# WOODMOOR WATER AND SANITATION DISTRICT NO.1

## LAKE PUMP STATION NO. 2 AND TRANSMISSION PIPELINE

### GRADING AND EROSION CONTROL PLAN

PPR-21-019

SHEET NO.  
**CE1.0**

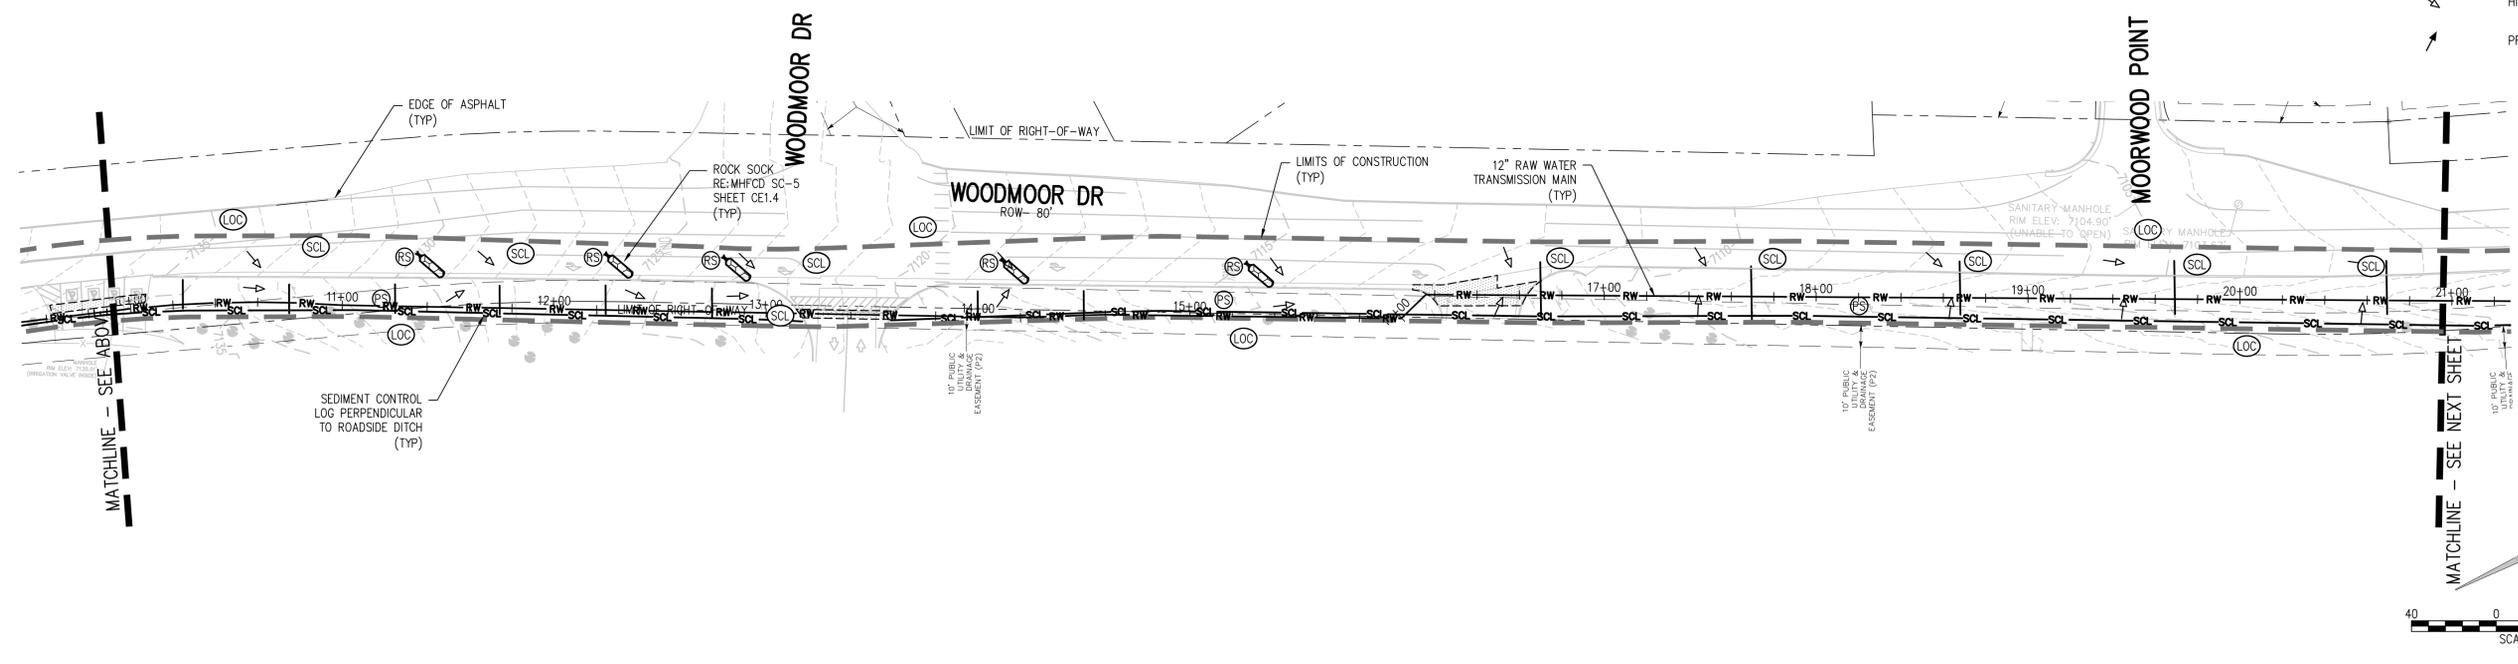
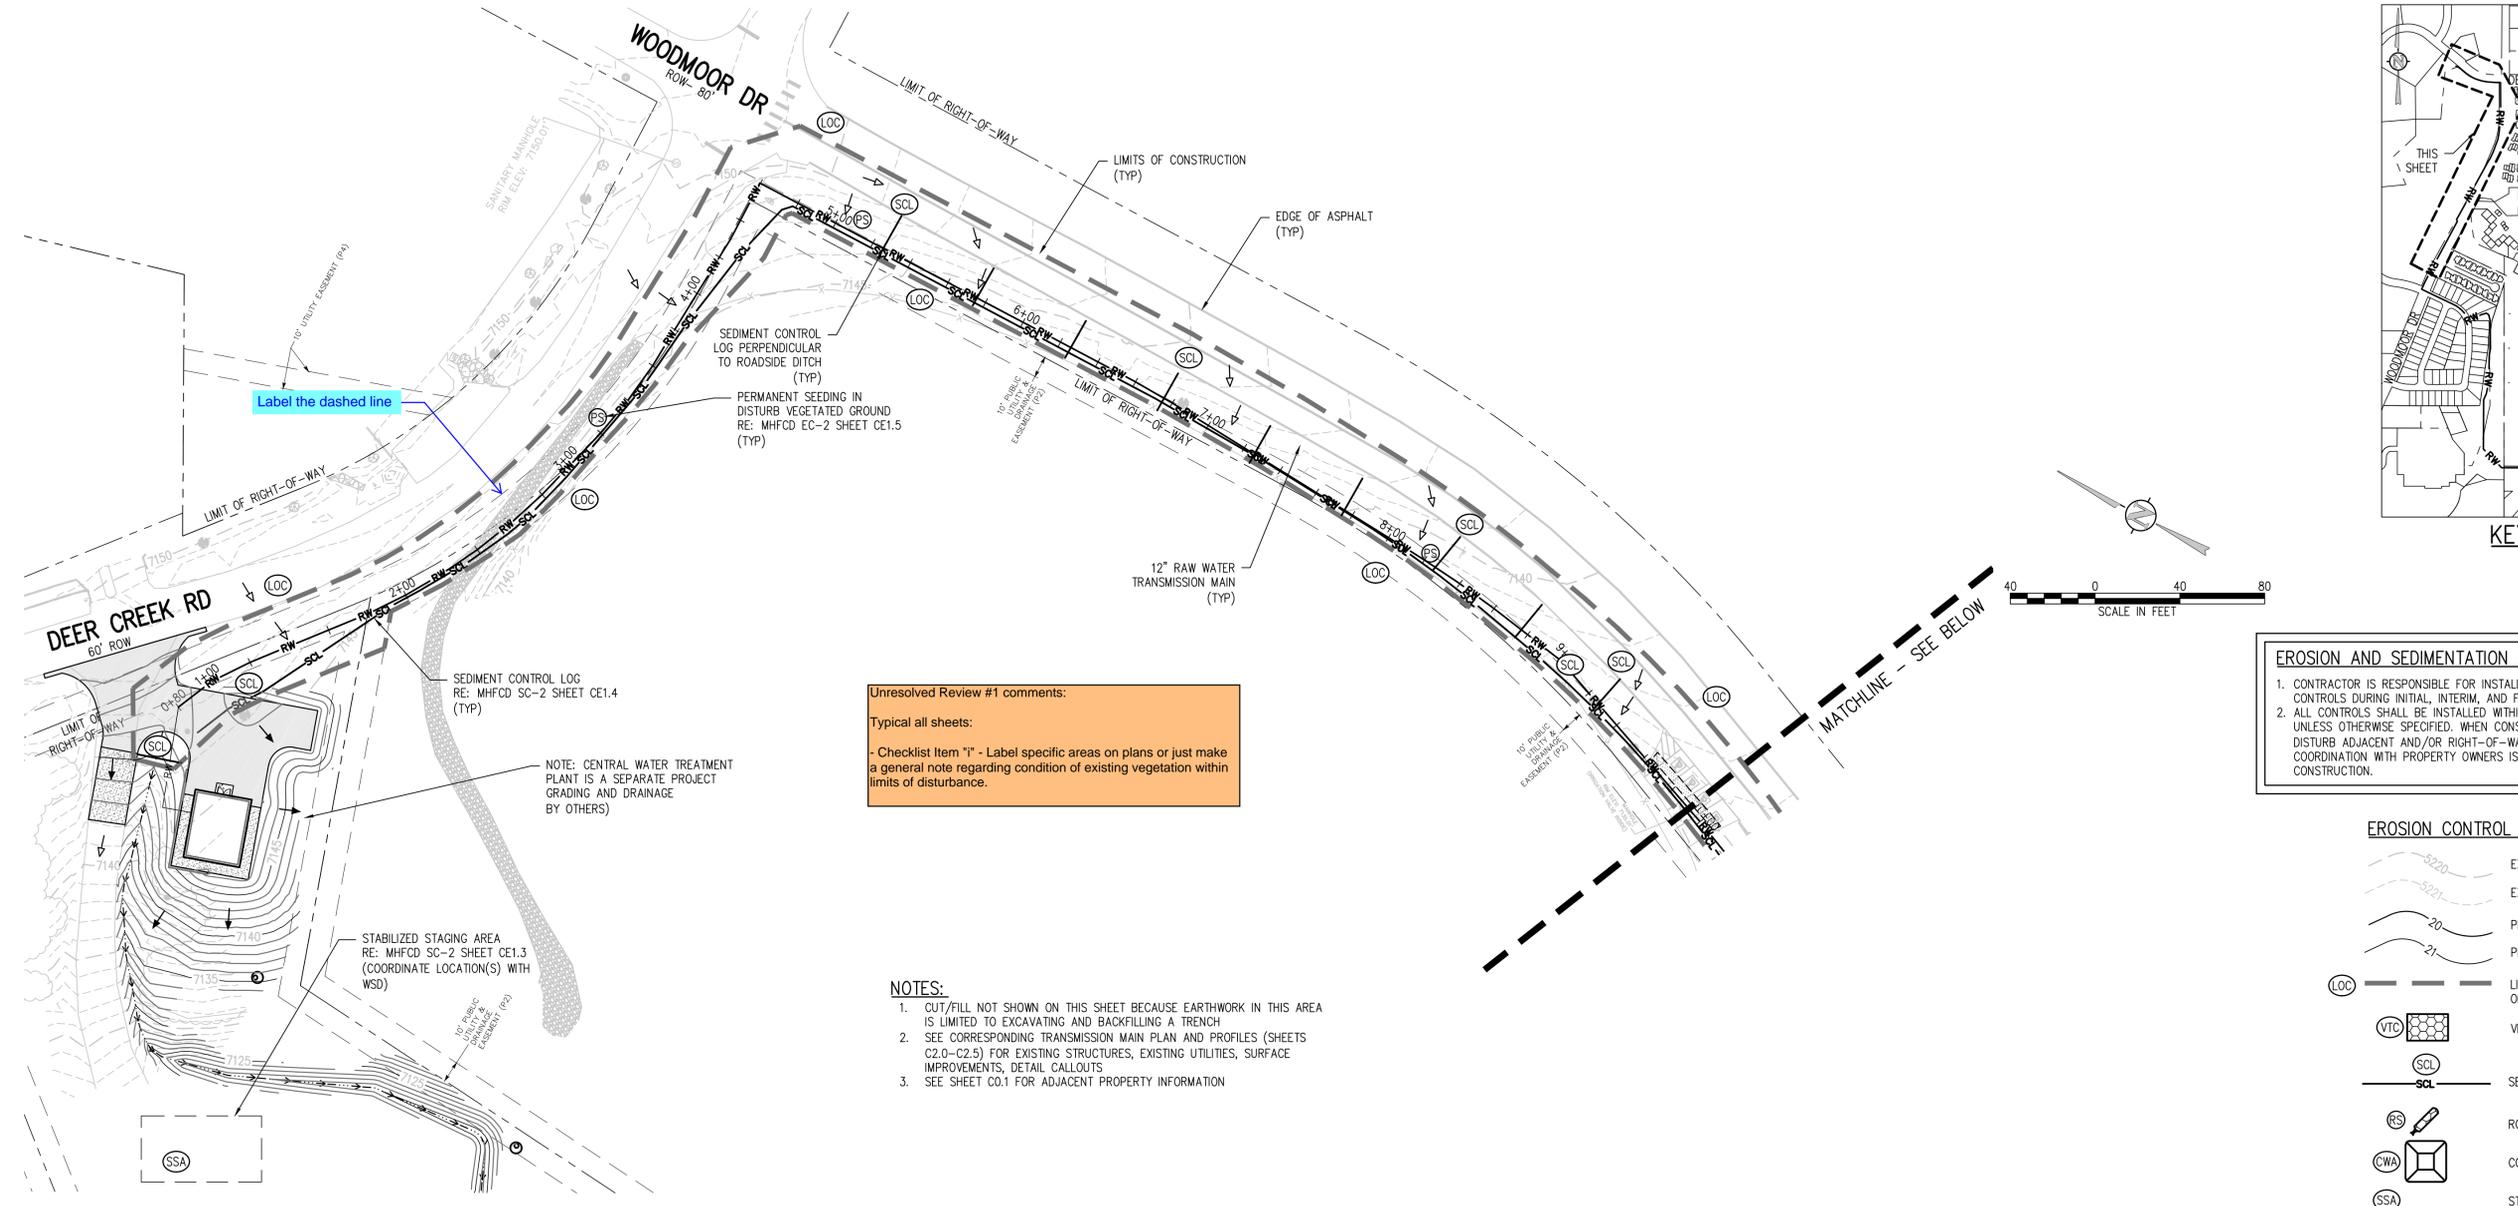
**Unresolved Review #1 comments:**

Typical all sheets:

- Checklist item "T" - Label specific areas on plans or just make a general note regarding condition of existing vegetation within limits of disturbance.
